October 24, 1995

SUBJECT: RESULTS OF NRC SOIL-STRUCTURE INTERACTION CONFIRMATORY ANALYSIS

Docket No. 52-003  
AP600

RESPONSE SPECTRA@NODE 3115  
AP6003D MOTION ALGEBRAIC SUM

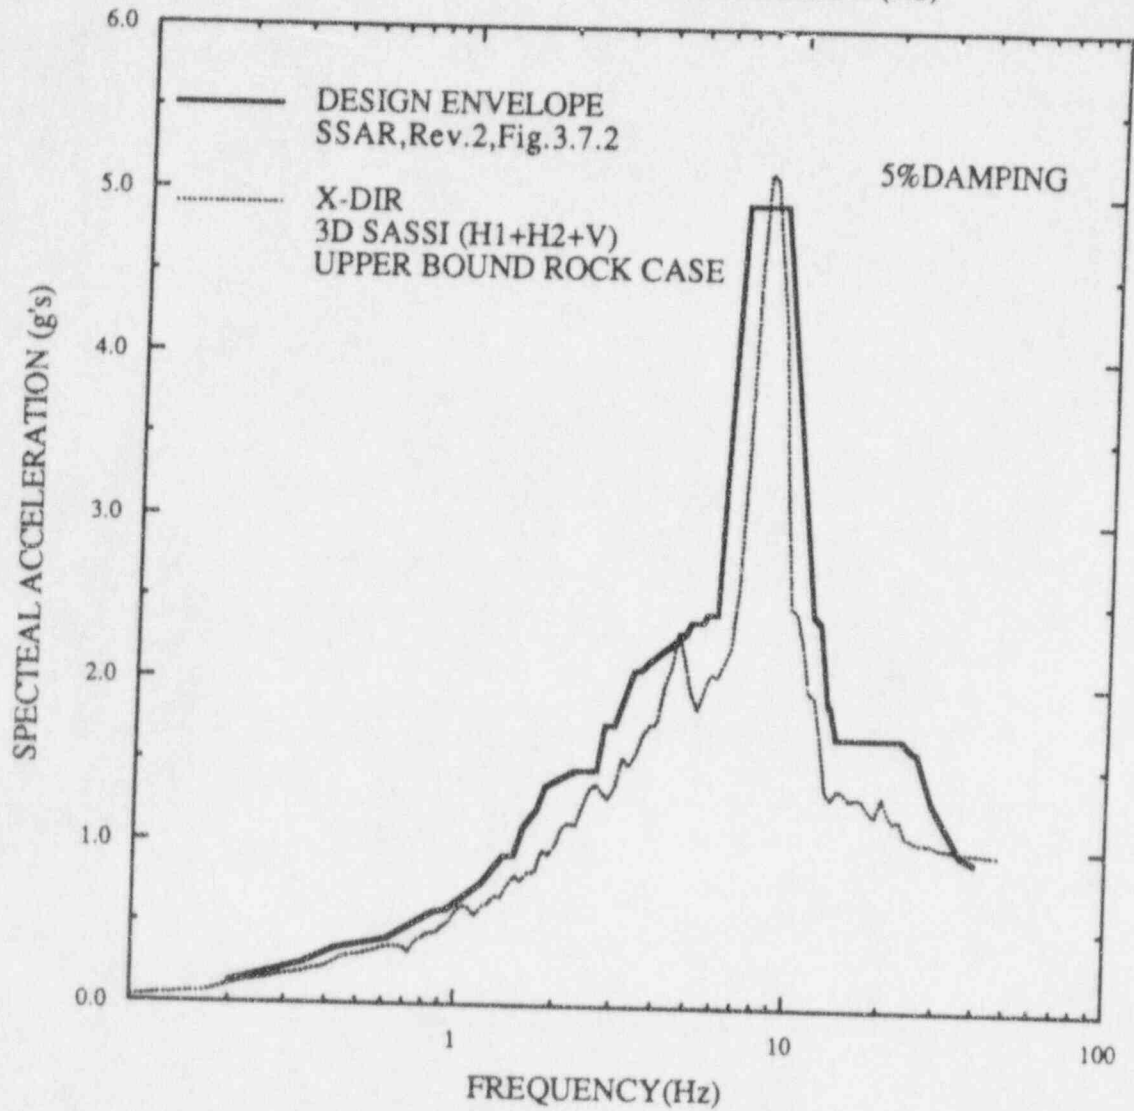
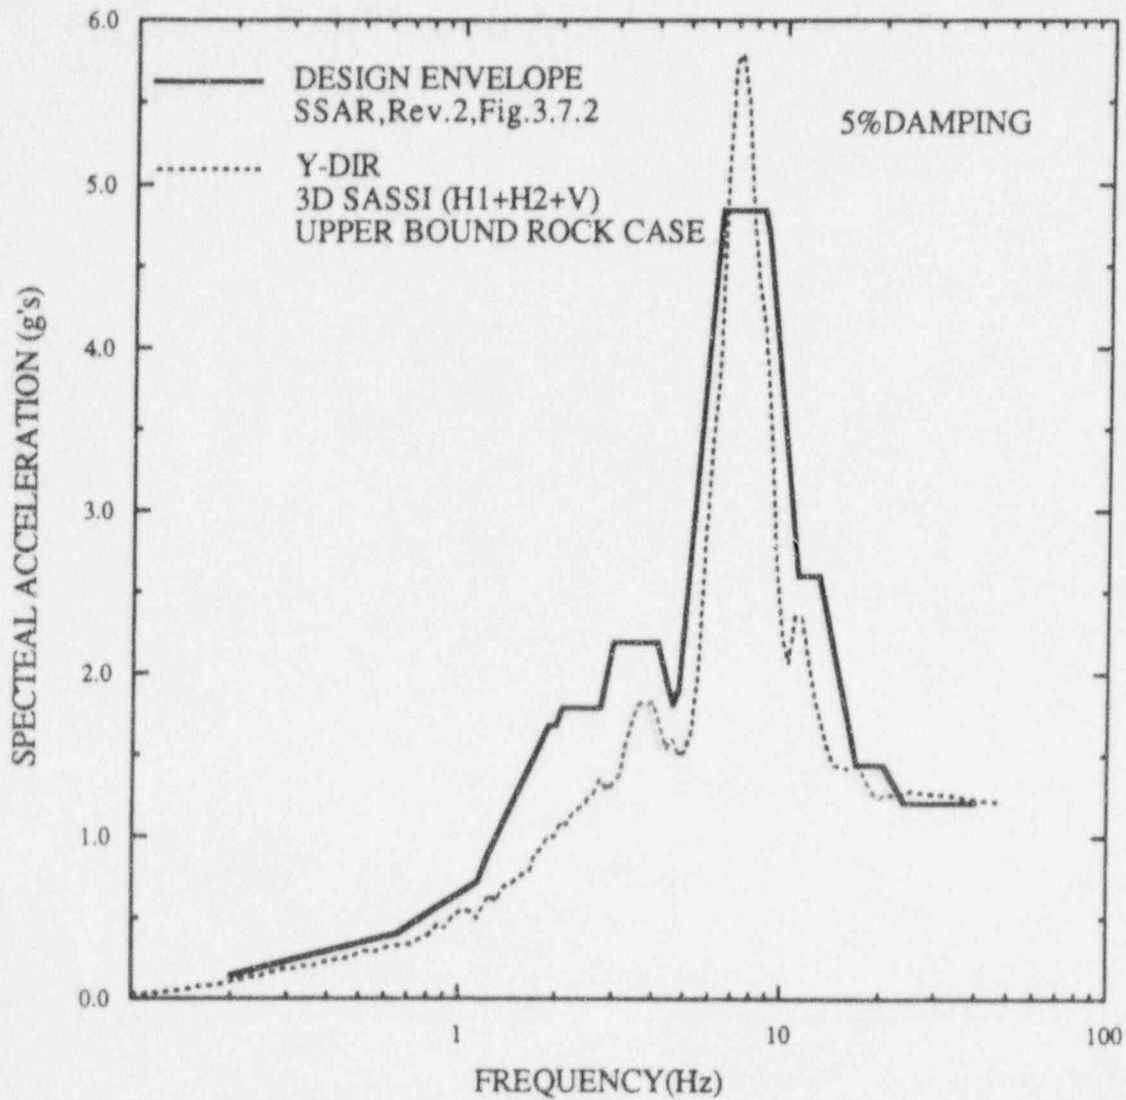
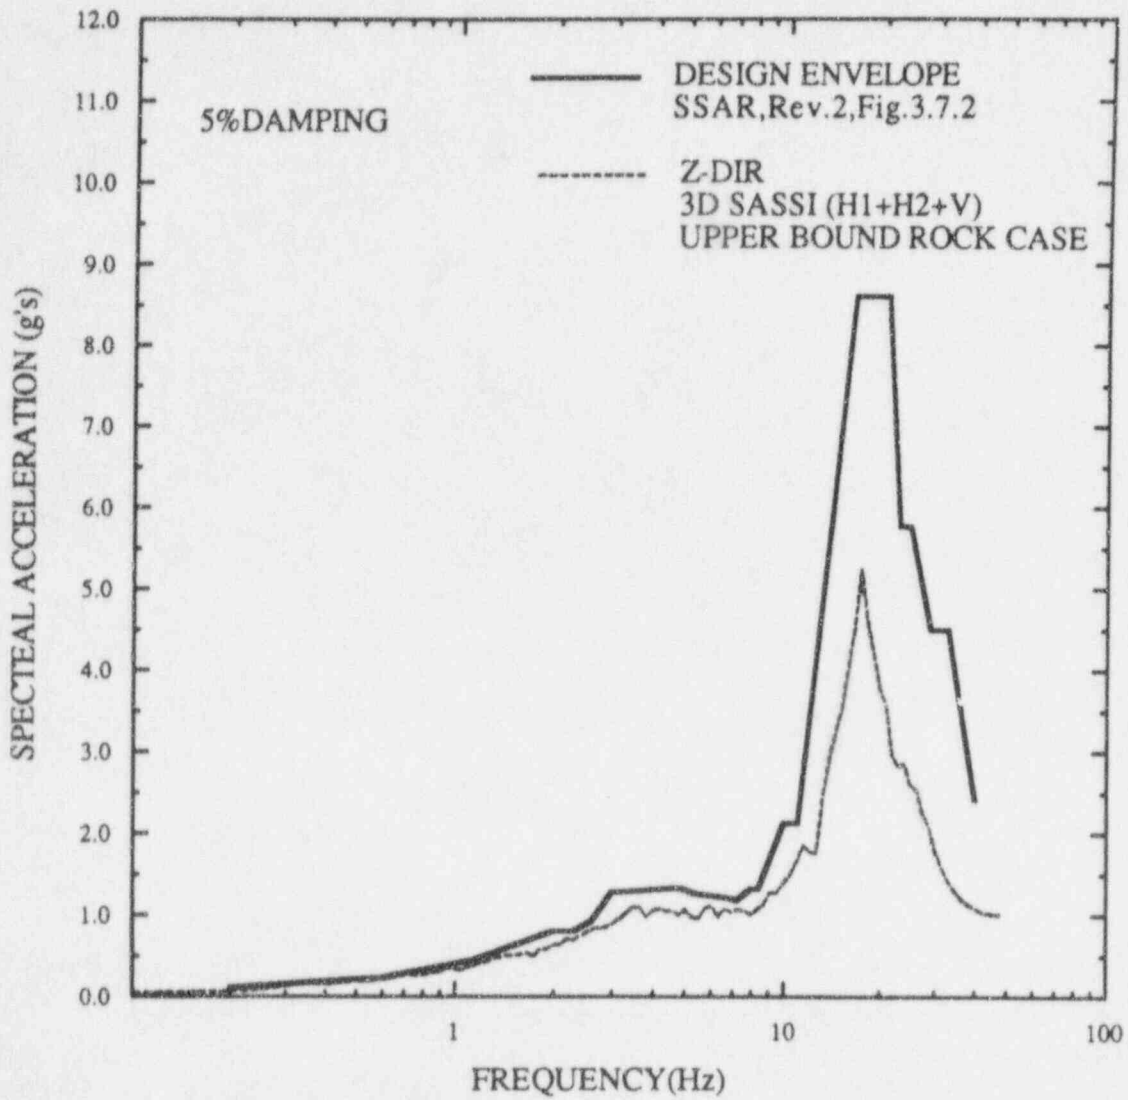
Enclosed is a set of floor response spectrum plots at four different locations of the nuclear island structures. As shown in these plots, results from the confirmatory analyses exceed design envelopes at the control room (Node 3004), shield building roof (Node 3016), top containment vessel (Node 3115) and polar crane (Node 3110). There is an indication that the four design site conditions documented in the SSAR may not adequately envelope the spectrum of potential sites in the United States. The staff realizes that Westinghouse is in the process of performing its SSI analyses for generating the final design floor response spectra. The enclosed floor response spectrum plots are for comparison and discussion at a future meeting with the staff.
